PROJECT
THE BARGAIN! SHOP
 1551 CATERPILLAR ROAD
 SUITE #202
 MISSISSAUGA ON L4X-2Z6
 (905) 949-5252
 (905) 949-5233
PROPOSED BUILDING
EXPANSION AT
GLENNWOOD PLAZA
FOR AVIADUS ENTERPRISES
 KESWICK, ONTARIO

Re: MINOR VARIANCE A02-24
443 The Queensway South
Plan Concession 3, Lot 6, Part 5 of RS65R8344 Parts 4-8 of RS65412426
ROLL NO.: 146-659

Re: A02-24

SITE PLAN

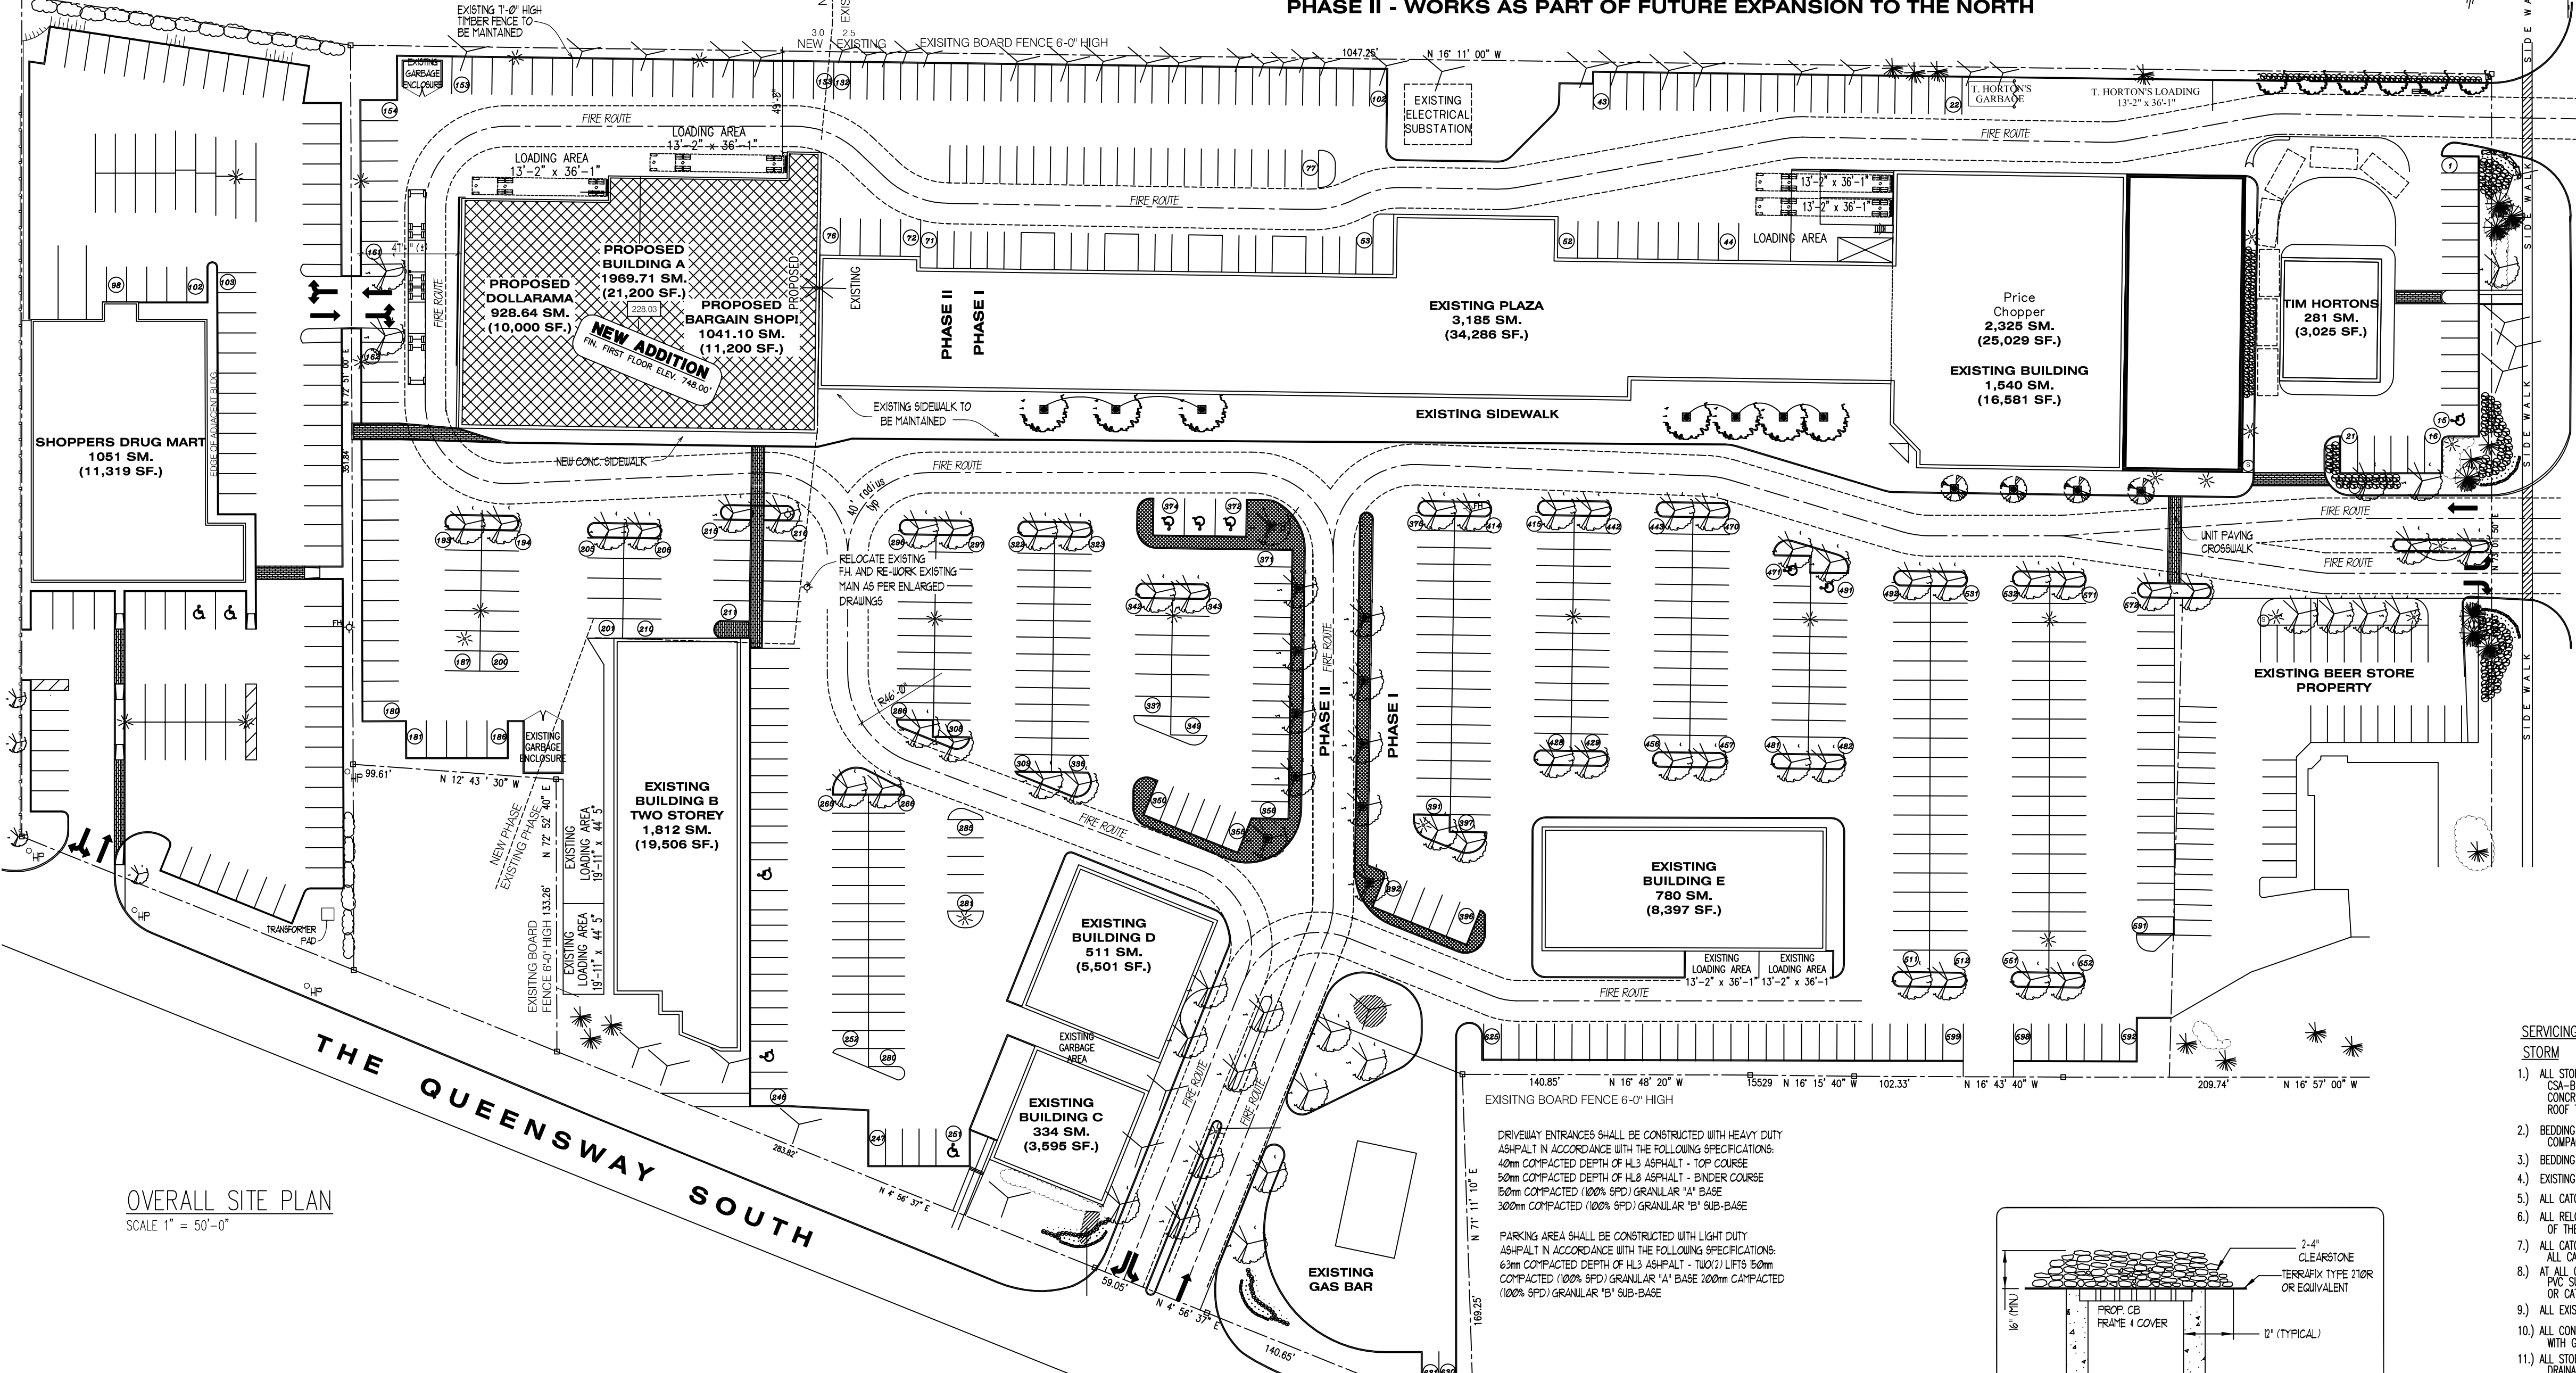
Ministry of Transportation		
Monavenir Catholic School Board		
MPAC		
Ontario Power Generation		
Rogers		
Southlake Regional Health Centre		
York Catholic Separate District School Board		
York Region - Community Planning & Development Services	May 1, 2024	<p>Comment:</p> <p>The fenced playground as proposed appears to be located within the 18 metres setback York Region is protecting for this section of The Queensway South. The playground needs to be located approximately 1.5-2 metres to the east of the existing property line so that is out of the protected setbacks.</p> <p>Condition of Approval</p> <p>The property is located on The Queensway South which is a Regional Road as identified on Map 11 of the YROP-2022 and protects for a road widening of up to 36 metres right-of-way. All setbacks will need to be measured from 18 meters offset from centreline of construction of The Queensway South.</p>
York Region District School Board

1. I am not in support of this application as it is.

2. If the application is to be approved however, the following requirements apply;
 - The location of the playground should be one with the building design, currently it is represented separately. This request is due to safety concerns, primarily as the current playground is proposed next to a parking lot which is frequented by many users separate to that of the child care. The other major concern is with the constraints with the actual site. The proposed location would require the children and staff to exit the building cross a public walkway to enter the playground.

- A landscaping buffer is not proposed in the current plan between the parking lot and the playground area, or on the east side of the Queensway. There is only 1500mm suggested in this location. Landscape buffers should be 2000mm minimum.

A circulation plan with gate locations as well as buffers, playground locations and the like must be provided. The ideal relocation for the playground area would be closer to the building, possibly repurpose the front entry concrete area and enclose it, or put it on the south side of the current pathway right next to the

building on the west side. Children should not be crossing a public path or a public parking to get to play areas. Sloping can be incorporated into the play elements such as balance challenges and retaining that double as play features. If the playground stayed on the south side of the pathway and right against the building it would allow for easy access for children from building to play elements and keep them tucked away from the parking lot so long as adequate height fencing was implemented along the entrance of the Plaza and The Queensway. The applicant would also have to exhibit that all playground standards have been met. (see attached photos)

The recommendation would again be to move the playground to the building, the way the space is programmed should be evaluated through a site plan.
